HISTORIC PRESERVATION COMMISSION
REGULAR MEETING
THURSDAY, APRIL 25TH, 2024
ASSEMBLY HALL
395 MAGNOLIA ROAD
PINEHURST, NORTH CAROLINA
4:00 PM

To: Historic Preservation Commission
From: Michael Mandeville, Senior Planner
CC: Alex Cameron, Planning Director
Pamela Graham, Planning Supervisor
Maria Carpenter, Planner
Shelby Grow, Administrative Specialist
Date: May 17, 2024
Subject: **Major COA Request for 80 Medlin Road**

To: Historic Preservation Commission
From: Pamela Graham, Planning Supervisor
CC: Alex Cameron, Planning & Inspections Director
Michael Mandeville, Senior Planner
Shelby Grow, Administrative Specialist
Date: May 16, 2024
Subject: **Major COA Request for 20 Muster Branch Road Involving Amendments to Previously Approved COA**

New Rear Elevation

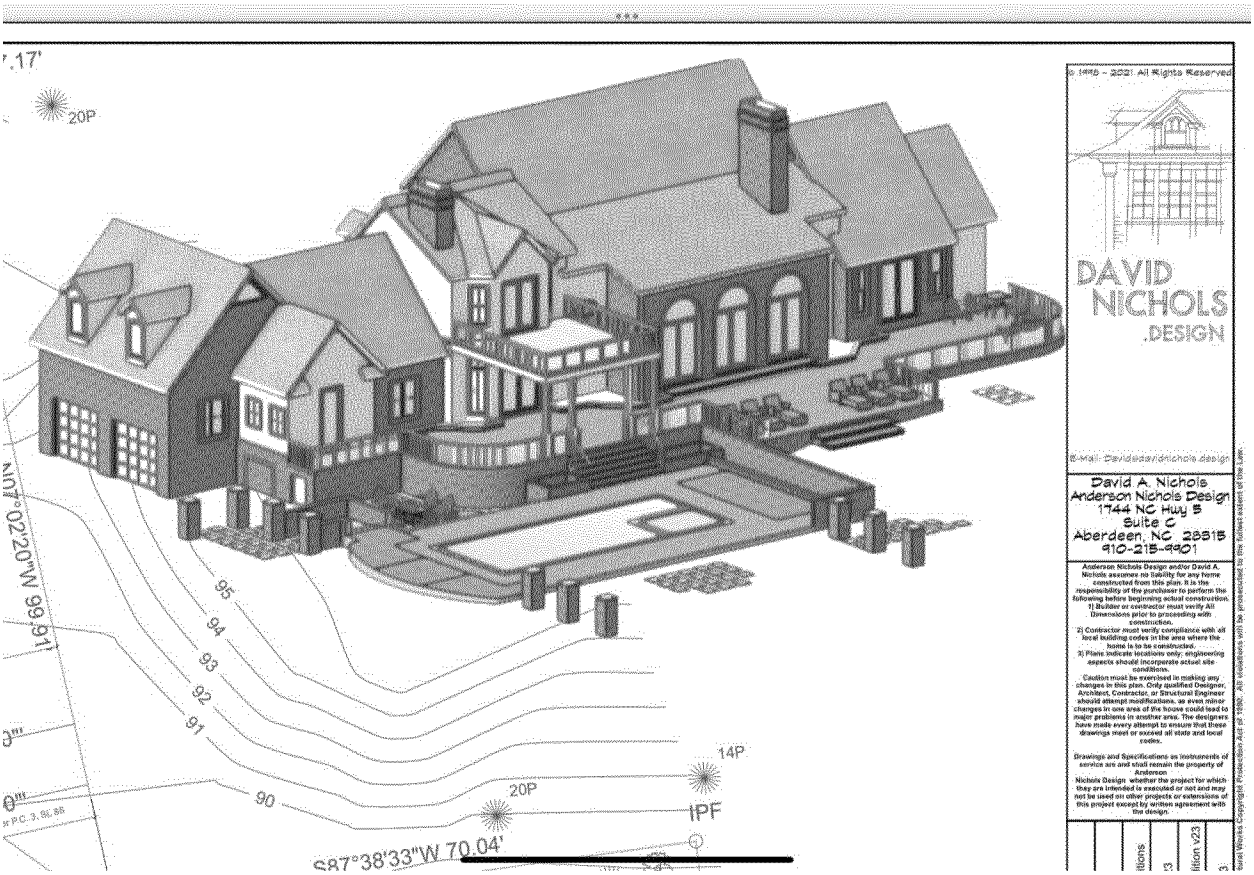
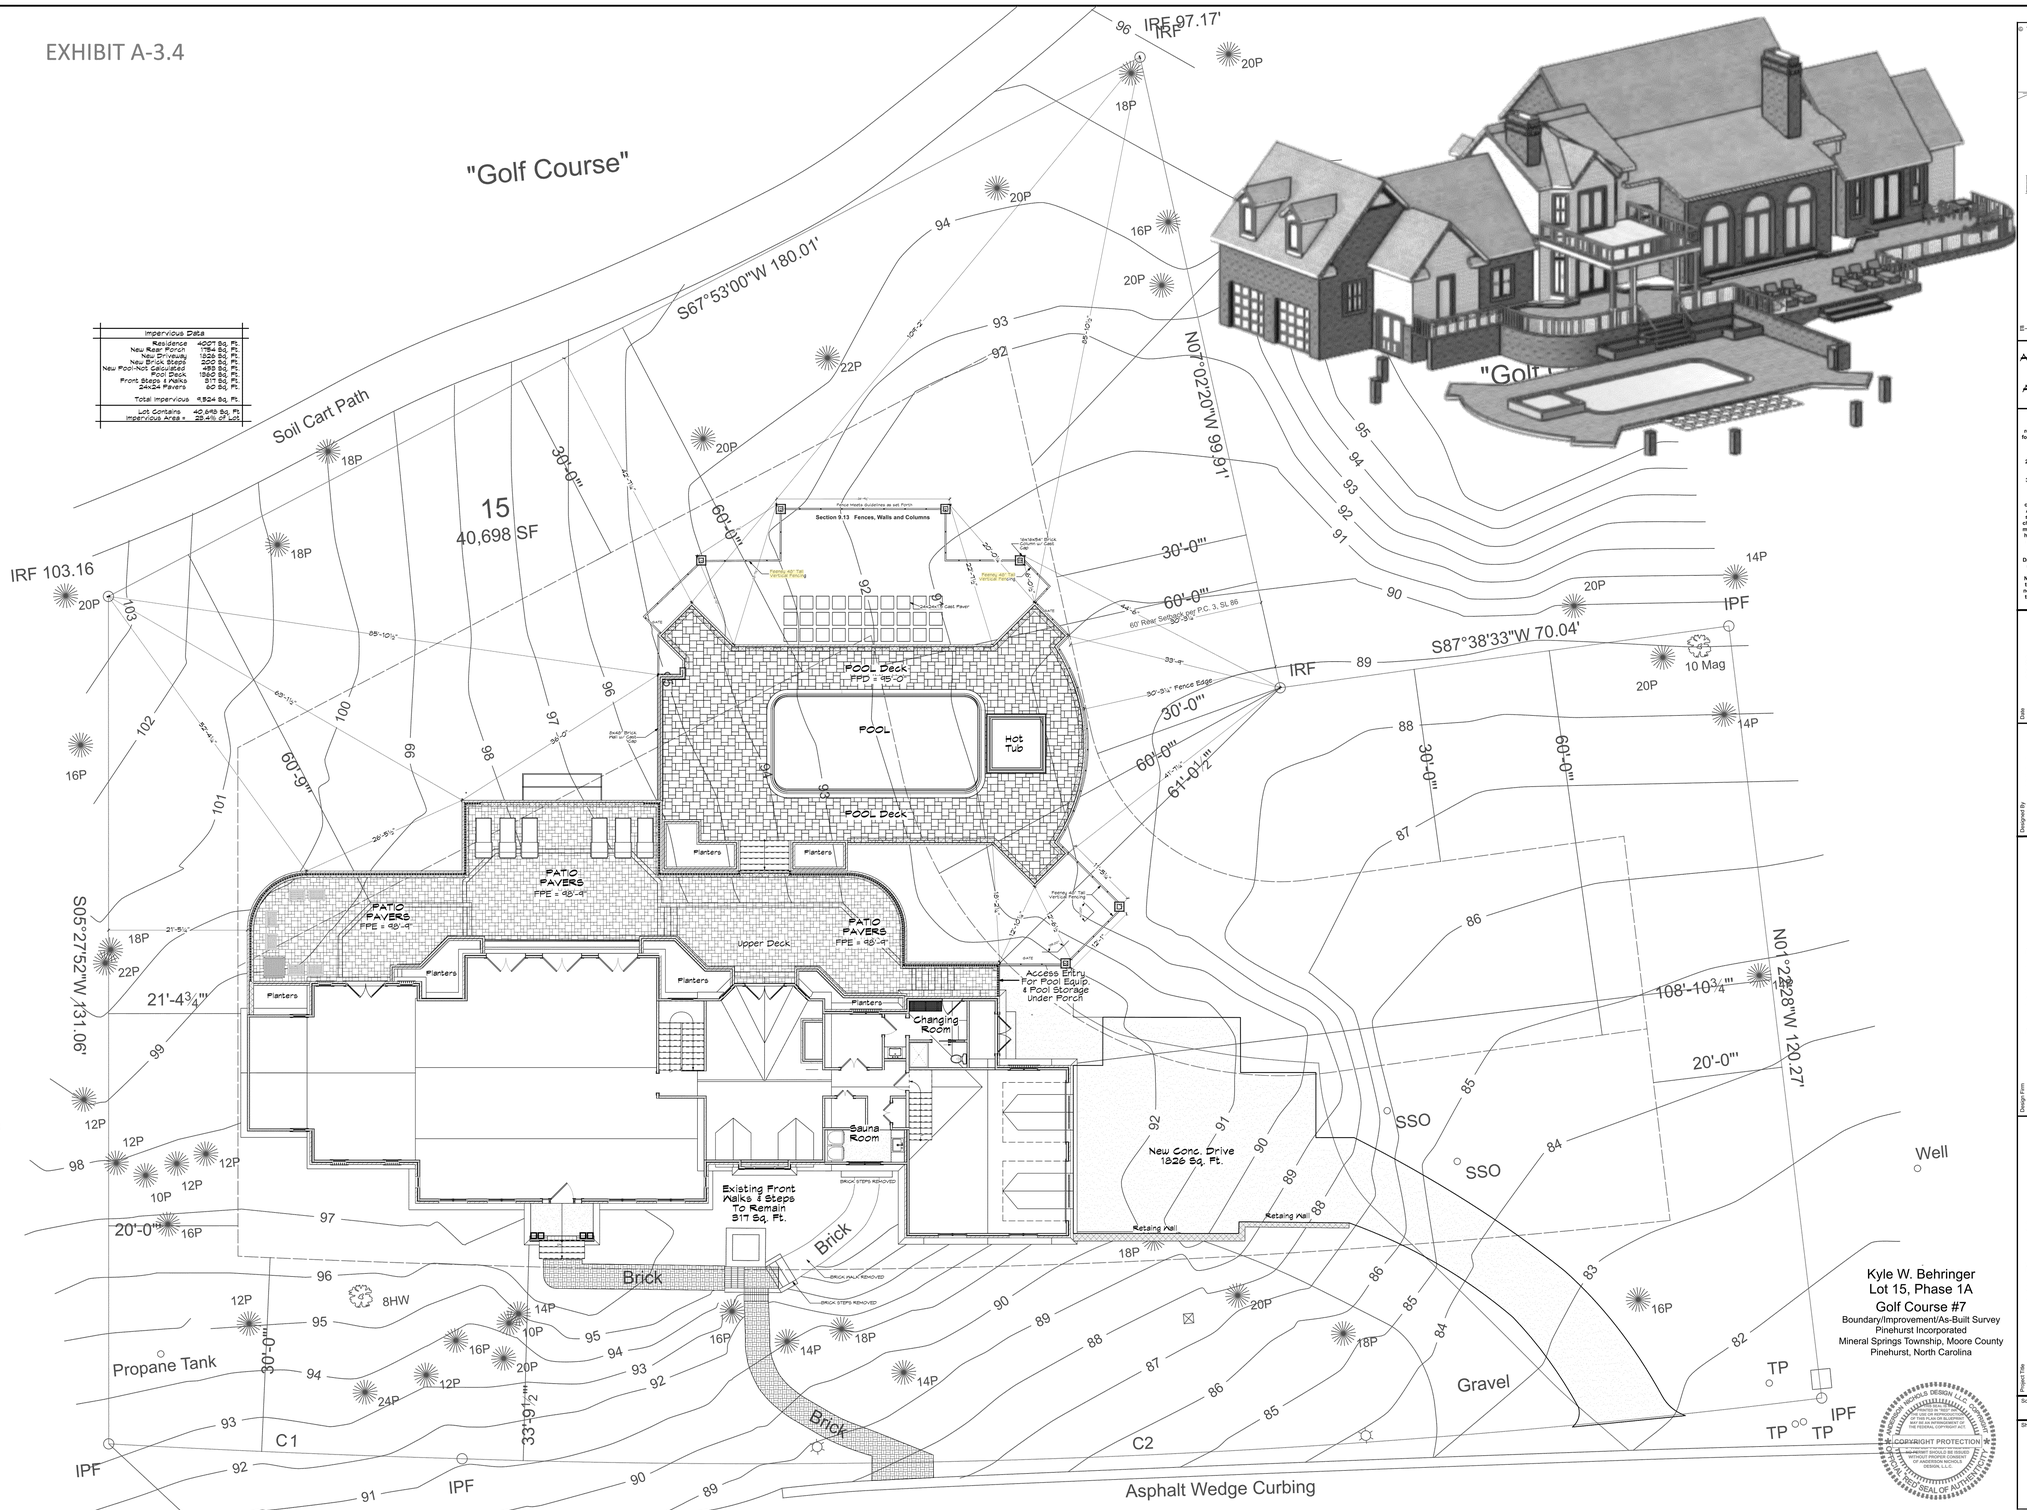
1. Rear/non-street side roof elevations – I only see one change, in the area leading out to the elevated terrace. Please confirm that is the only change to the roof. Pointing this out on the elevation exhibit would be helpful. The rear elevation changed due to the necessity to change the new roof line that extends along the rear roofline at the observation deck. The original design for the roof line did not adequately accommodate the use of the interior space leading to the observation deck. Additionally, two windows were added on the garage/rear side elevation. Those changes are highlighted on the new elevation drawing entitled, "Rear Elevation COA 2024 00062".
